Addendum 02

DOCUMENT 00 91 00

DATE: January 29, 2026

PROJECT: Tipp City Seniors New Addition
528 North Hyatt Street
Tipp City, Ohio 45371

BUILDING SECTIONS

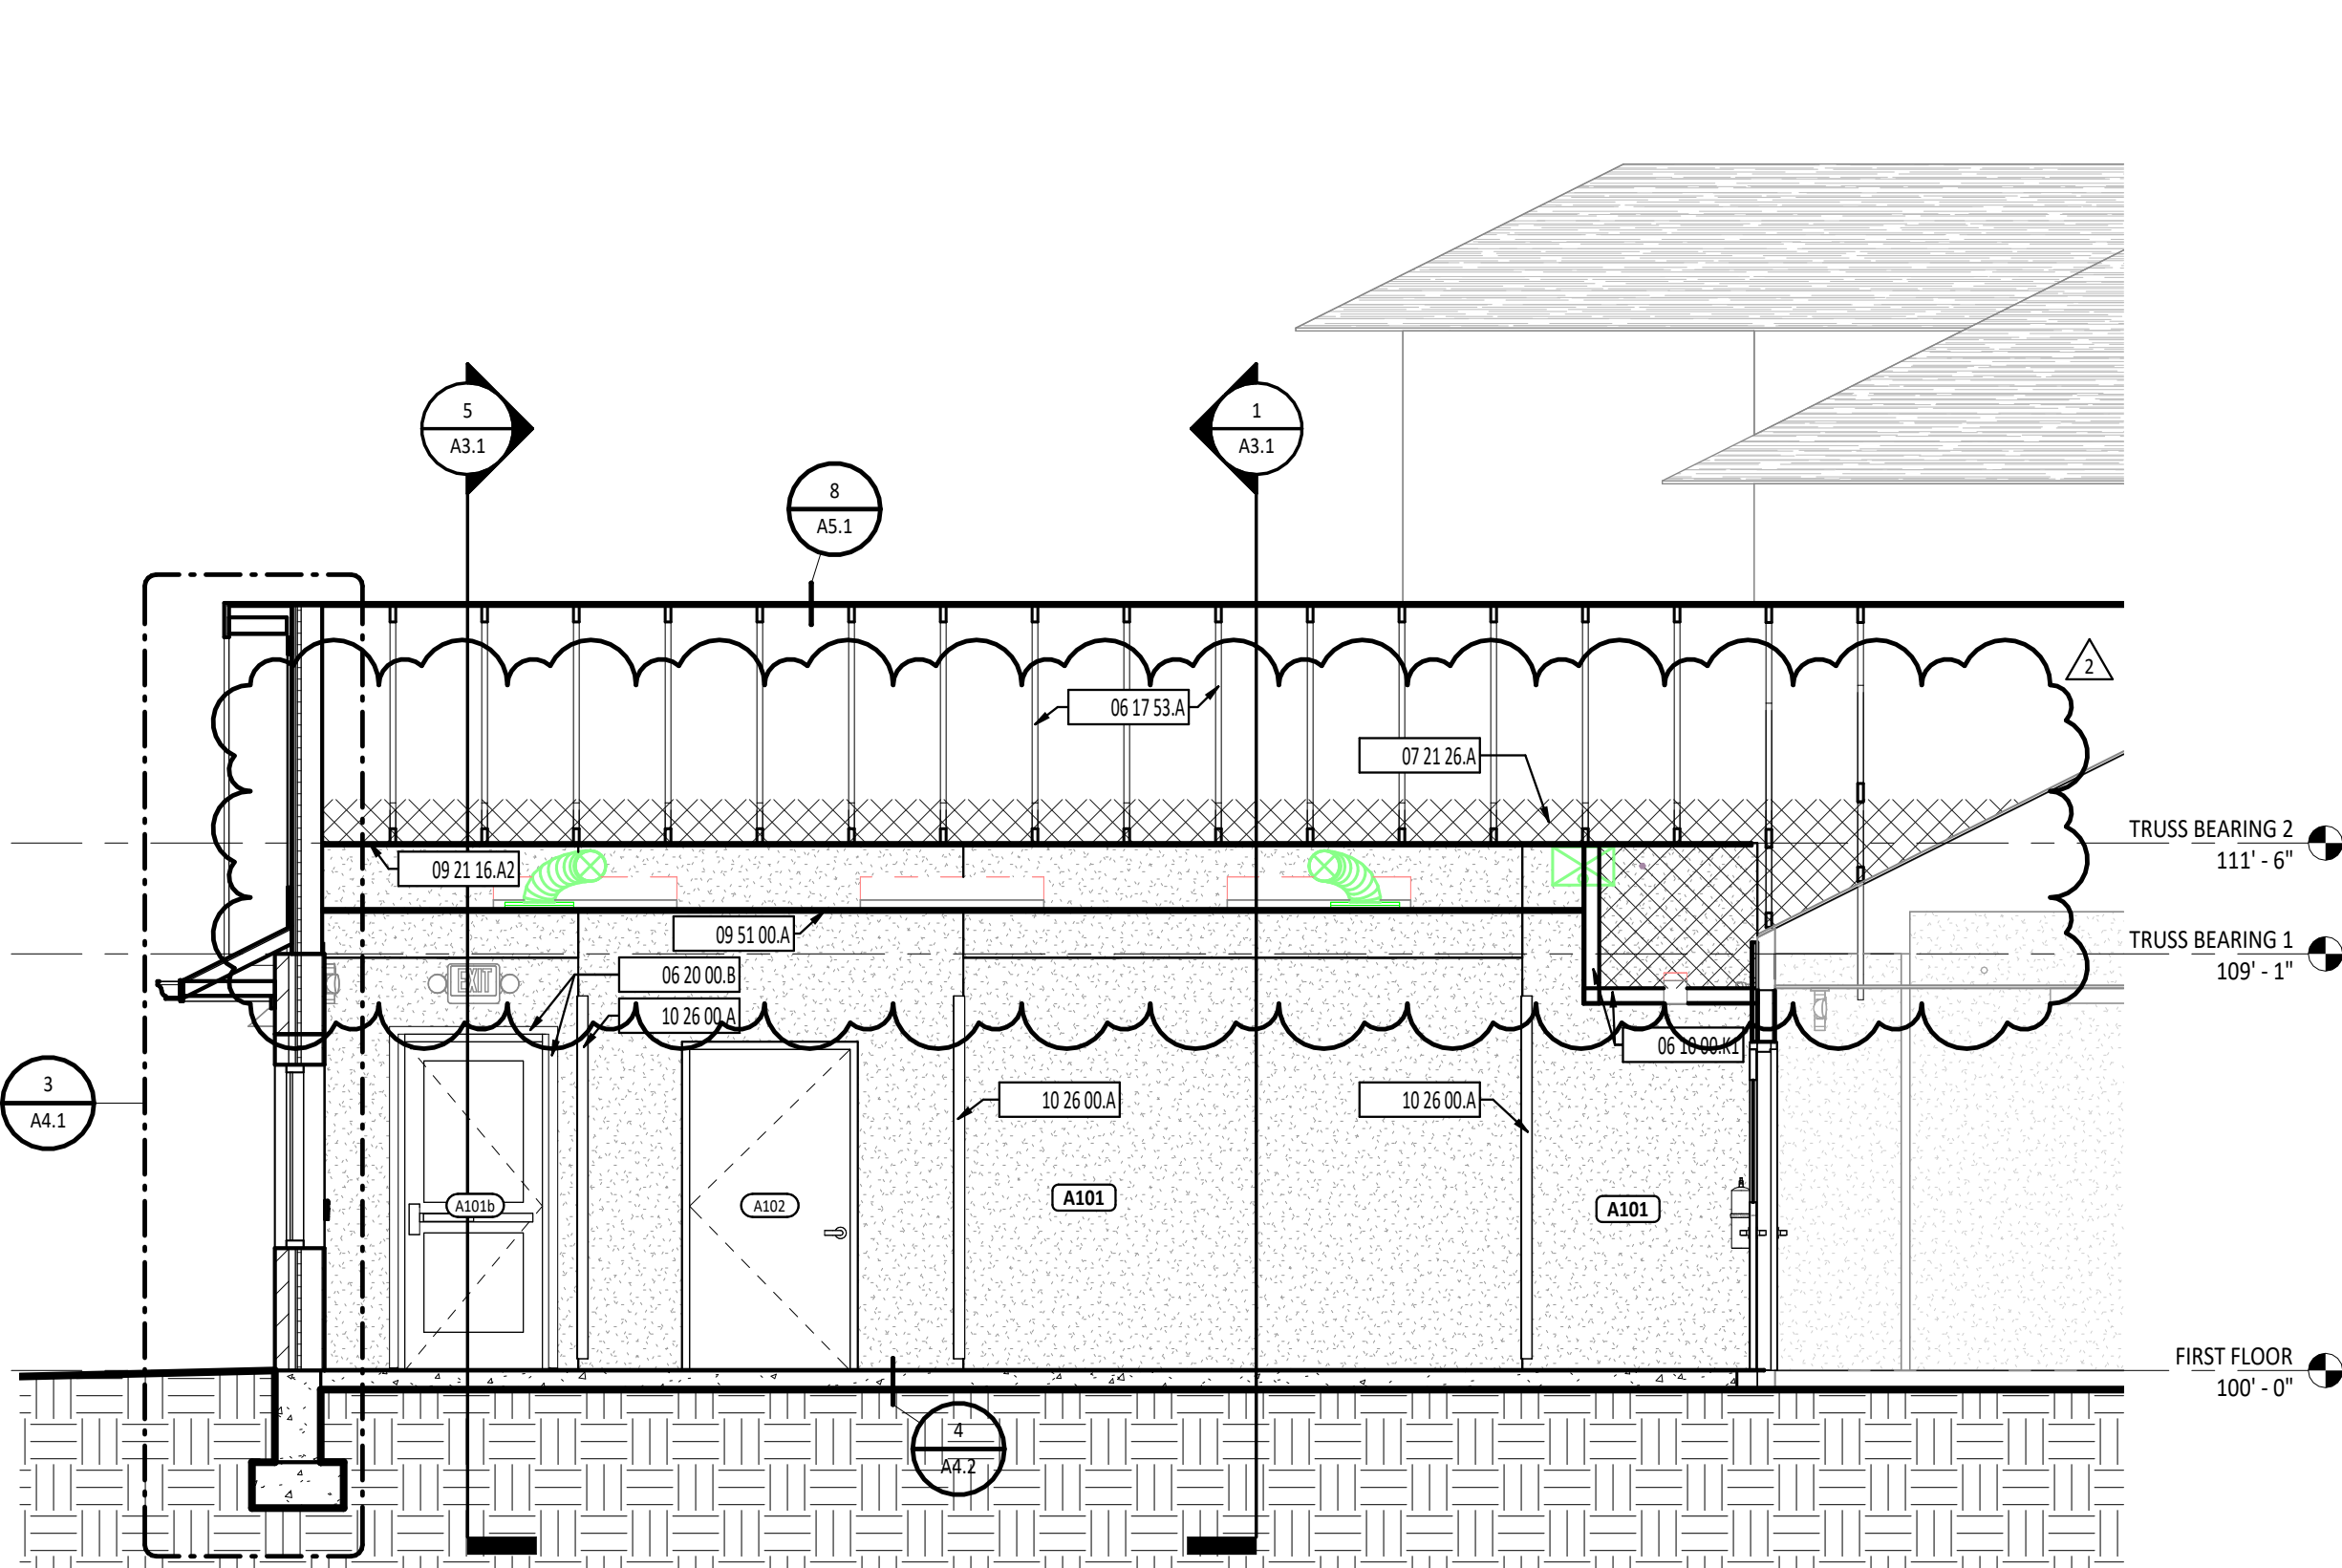
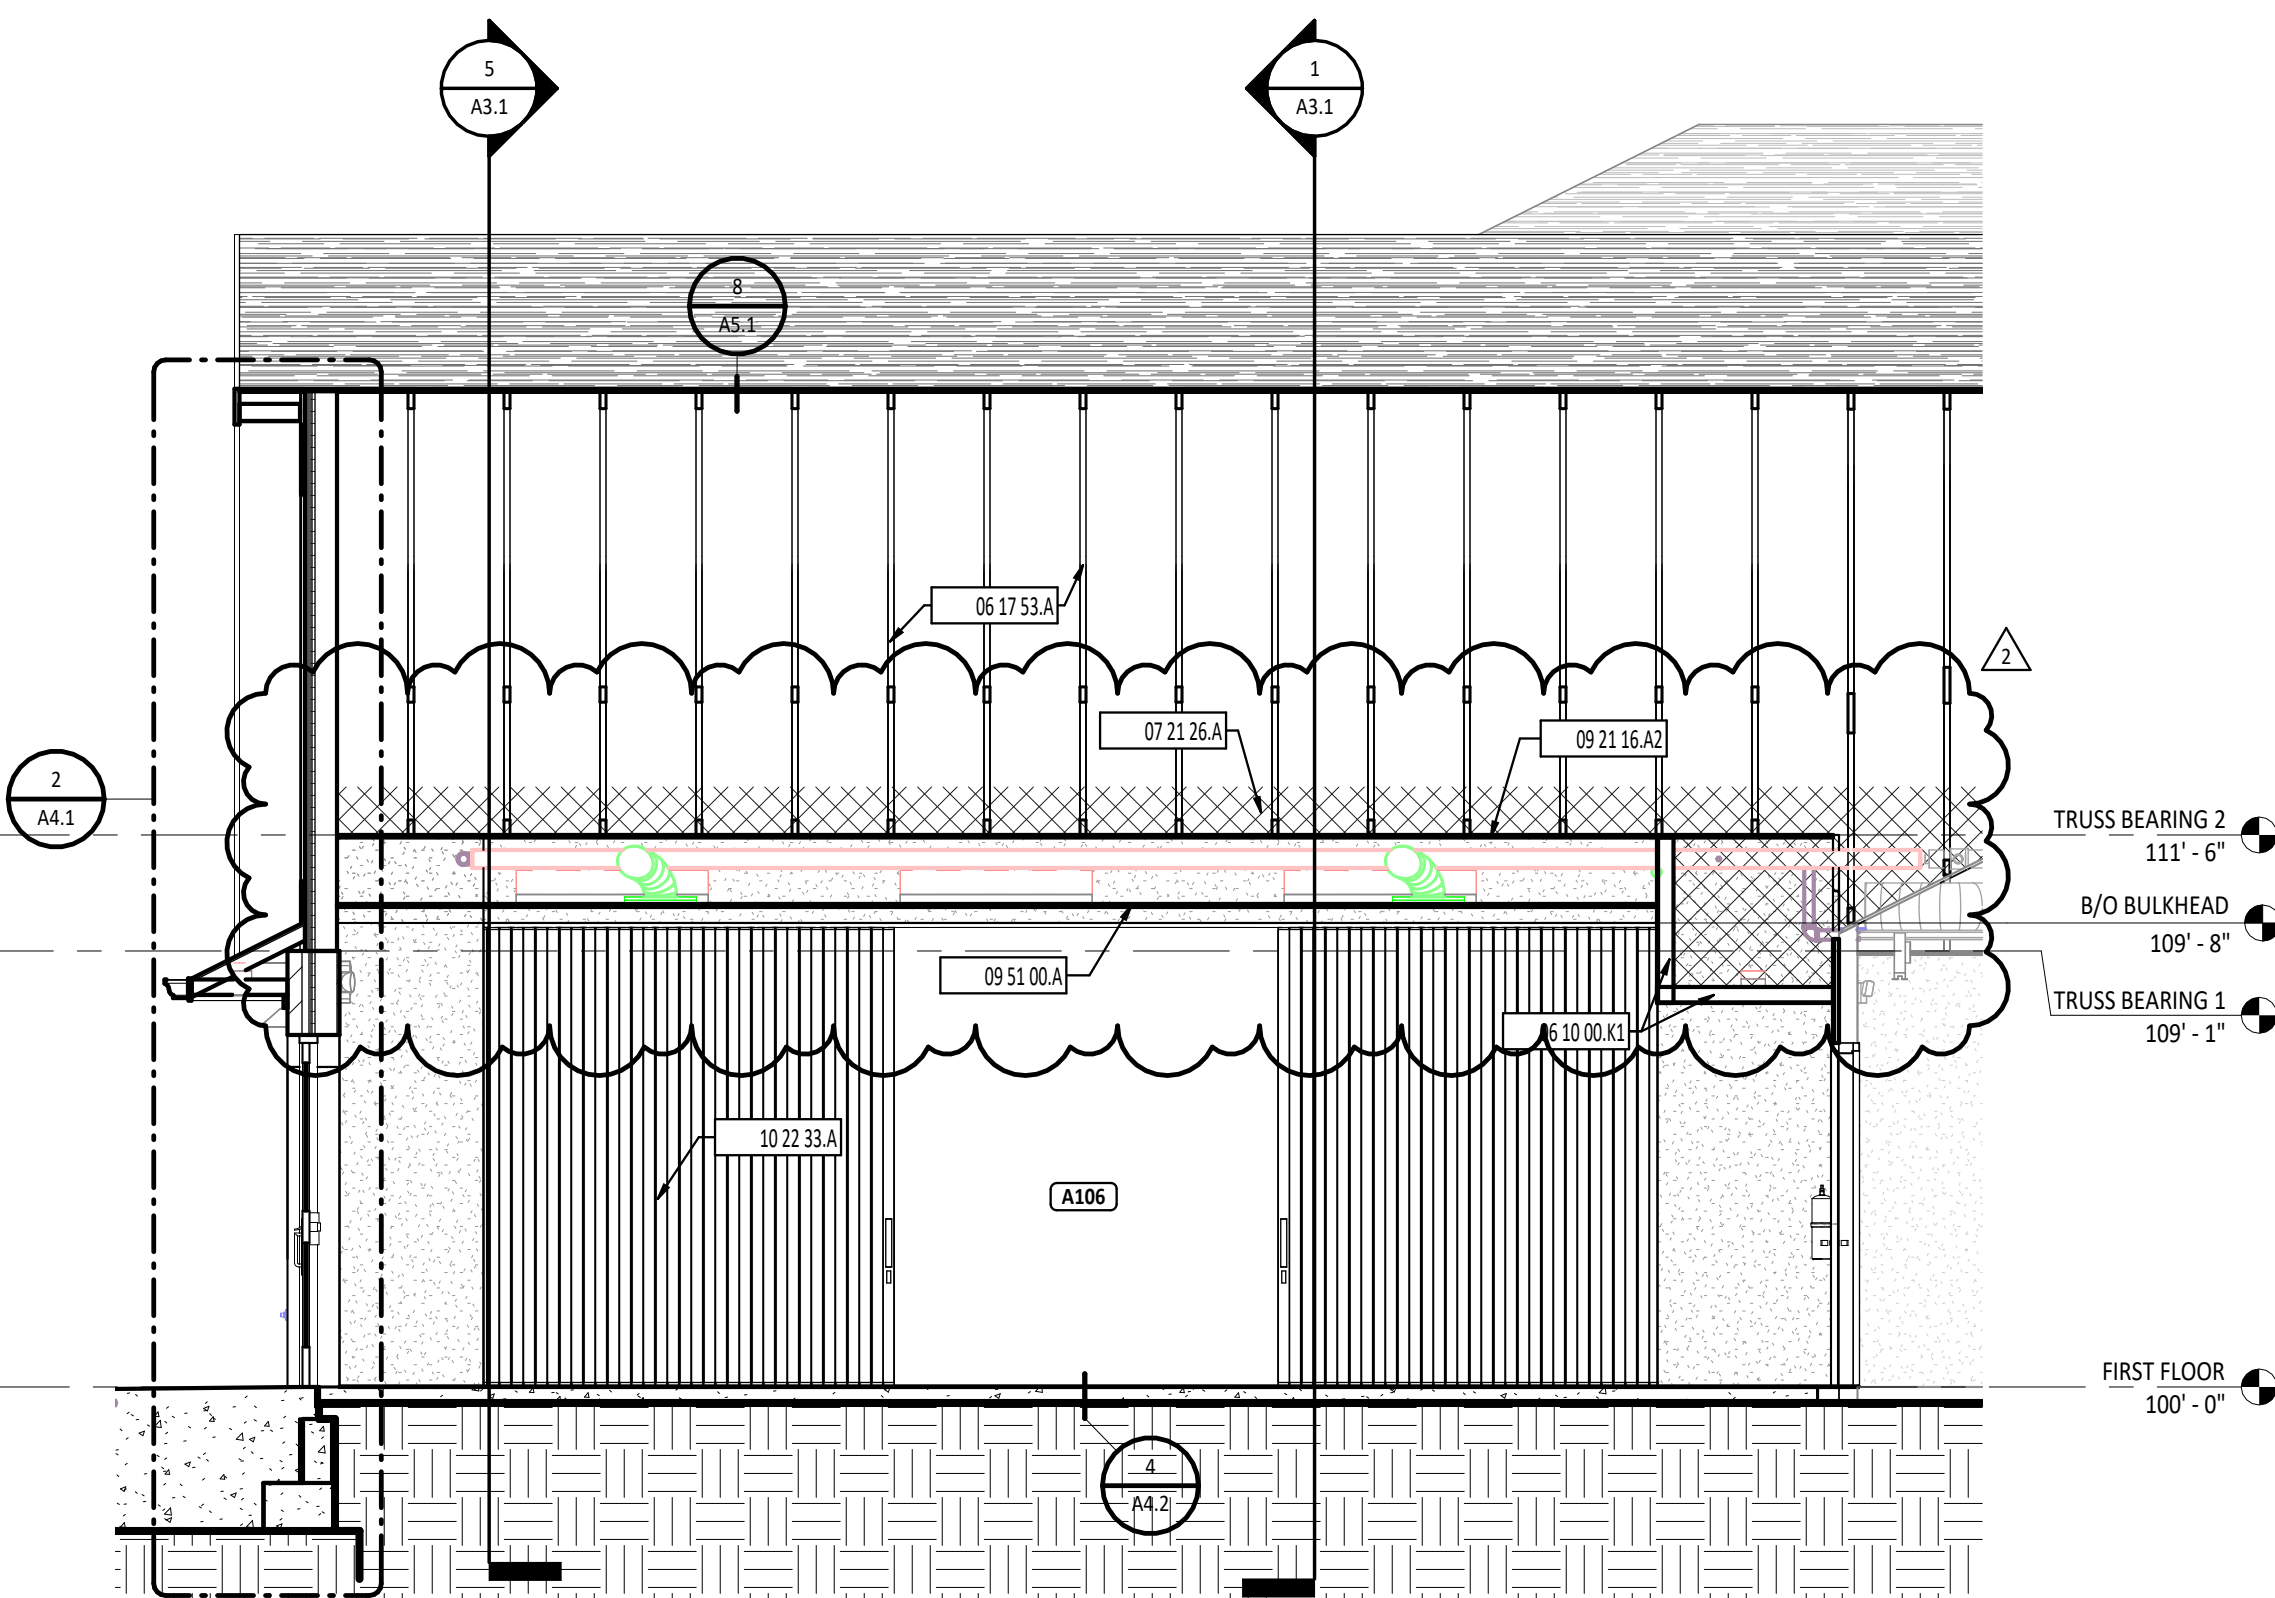
1. Drawing Sheet A3.1 Building Sections:
 - a. Added blown insulation in concealed areas where required.
2. Drawing Sheet A4.1 Wall Sections:
 - a. Added additional blown insulation to detail 5/A4.1.
